Drain: SCARBOROUGH FARMS DRAIN **Drain #:** 205
Improvement/Arm: SCARBOROUGH FARMS - SECTION 1
Operator: JDH **Date:** 4-28-04
Drain Classification: Urban/Rural **Year Installed:** 1985

RE: Scarborough Farms Drain

Re: Scarborough Farms Drain

Re: Scarborough Farms

ROAD & DRAINAGE PLAN

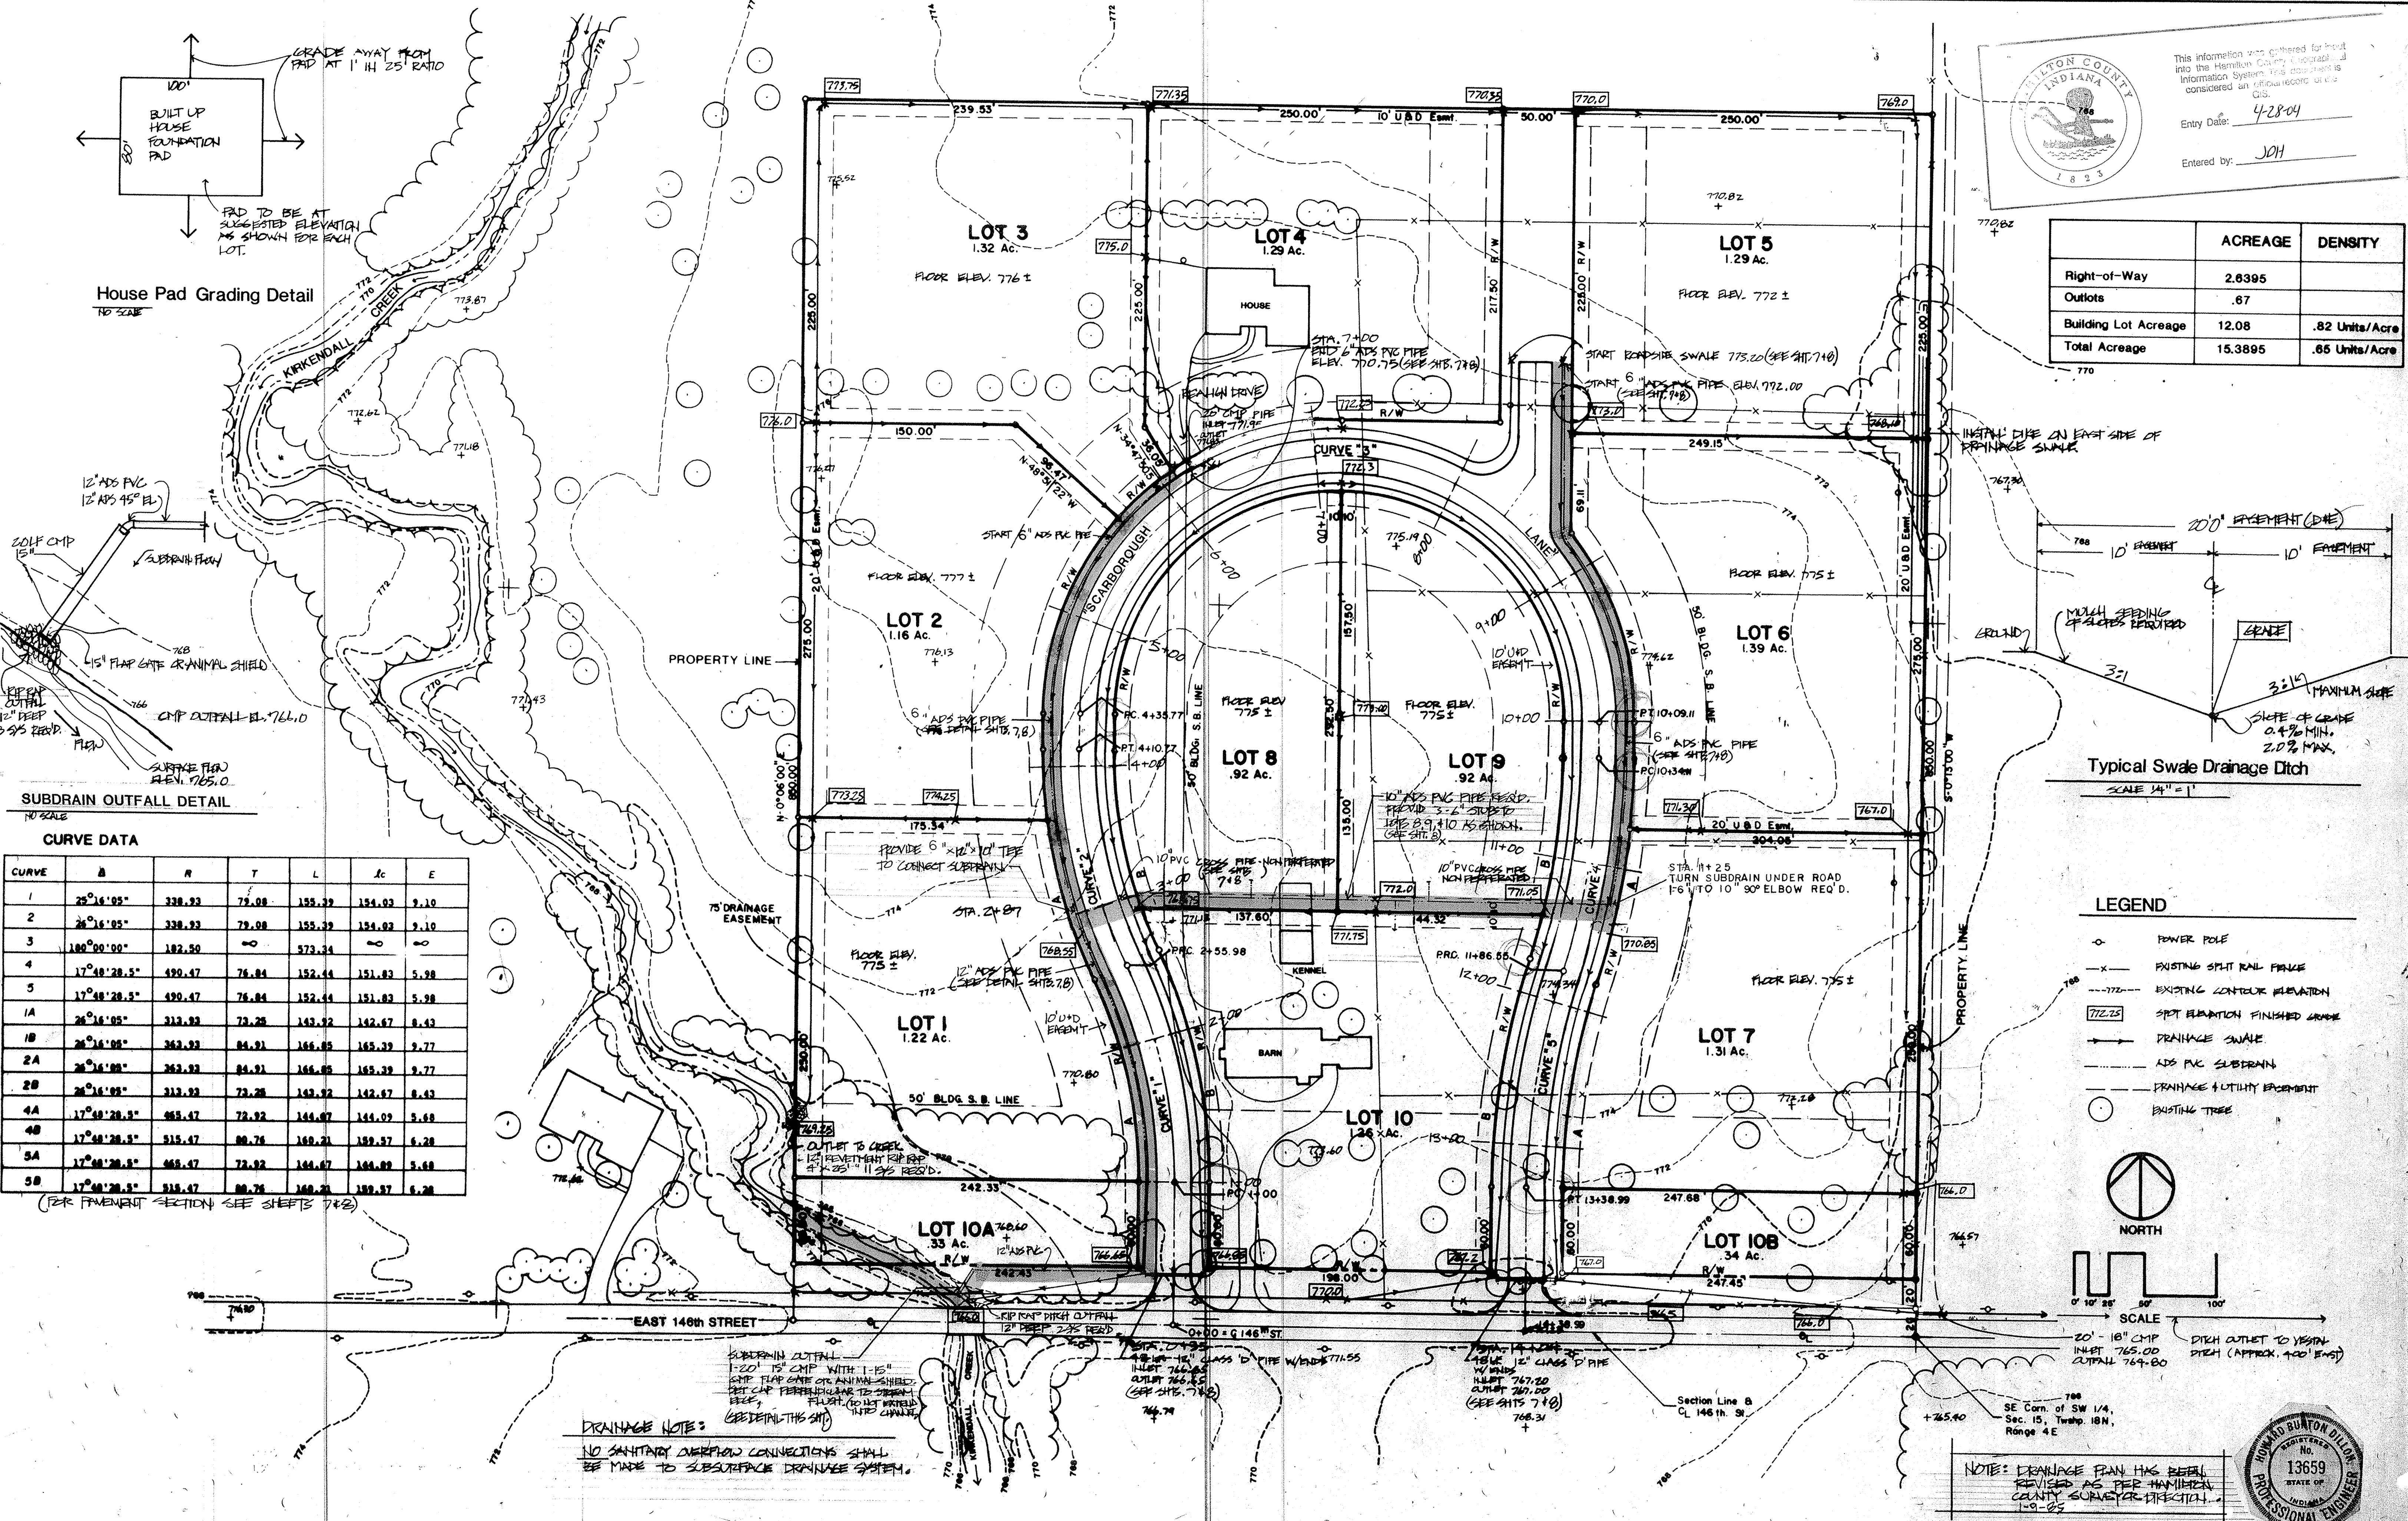
NOTE: DRAINAGE PLAN HAS BEEN REVISED AS PER HAMILTON COUNTY SURVEYOR DIRECTION 1-9-05

1-10-05	SUBDRAIN, EASEMENT, OUTFALLS KP AS DIRECTED BY HAN. CO. SURVEYOR 1-9-05	DEGN BY HED	12-10-04
		DR H BY KP	12-13-04
		TRCD BY	
		CK D BY	
		APP D BY KP	1-7-05
